Service Bulletin 28

(a) Service Bulletin No:	28
(b) Revision / Date	0 / 15-January-2020
(c) Title:	Stratus Double Burner, Burner Hanger Inspection
(d) Description:	Inspection / Replacement of Stratus Double Burner Hanger.

SB28: Accomplishment Instructions.
Stratus Double Burner; Mounting Hanger Inspection.

CBL/TN/DCB/3191

Fig 3. Burner Serial Number (296) & Part Number (CB8720) engraved on the hanger

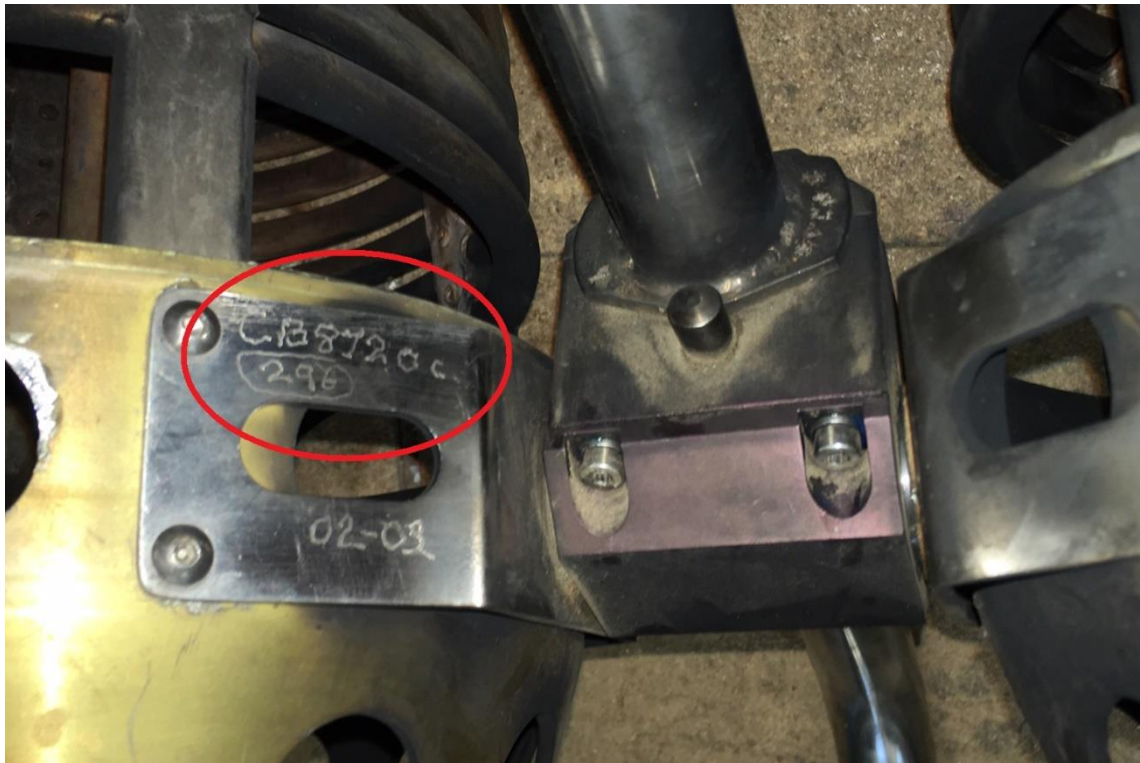
- 2.1.1 The affected hangers were fitted to double burners with serial numbers 320 or lower. The burner serial number is hand engraved onto one of the hanger end plates. Should the burner serial number be unreadable or missing Cameron Balloons can identify the burner from the manifold block serial numbers (machine engraved onto the upper surface of the burner manifold block).

Fig 4. View of Hanger Assembly.

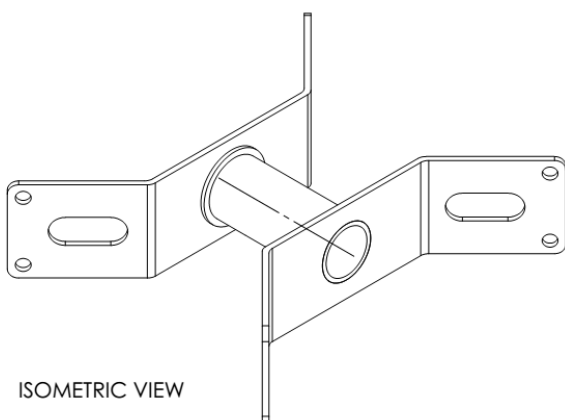
2.1.2 Affected hangers (Issues A through C) have either no machine engraving or have “Cameron Balloons Limited” machine engraved in the upper right-hand corner of the end plate. Non-affected hangers (Issue D and E) have the text “Cameron Balloons Limited” machine engraved in the lower right-hand corner of the end plate.

Fig 6. View of the affected weld. Note burner coil removed for clarity.

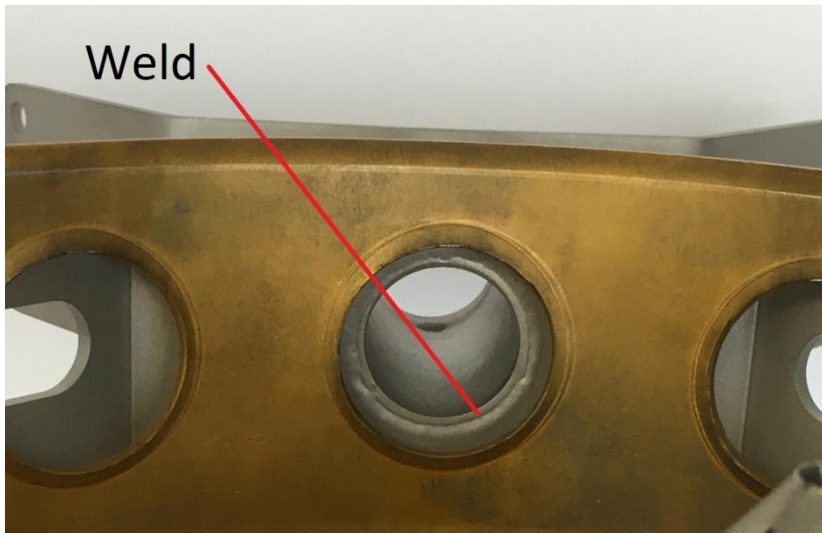
- 3.1.1 The weld in the end of the hanger can be seen through the holes in the can. A torch and a mirror may be required to give a clear view.
- 3.1.2 Remove any soot or dirt prior to inspection. WD40 or kerosene (paraffin) is the preferred cleaner; some solvent cleaners may damage the finish of the can.
- 3.1.3 Inspect the weld for any signs of cracking. Attempting to move the burner relative to the hanger may assist in making the crack visible.
- 3.1.4 If a clear view cannot be obtained or there is any doubt then the hanger must be removed from the burner. The burner is mounted to the hanger with M5 fasteners CY-0005-1004, CY-0005-1016, and CY-0005-2009. A single M3 screw secures each burner manifold block to the tubular handle.
- 3.1.5 Cracked hangers must be replaced before further flight with a new part CB-8504-0000 Issue D or later. **Cracked hangers must not be re-welded.**
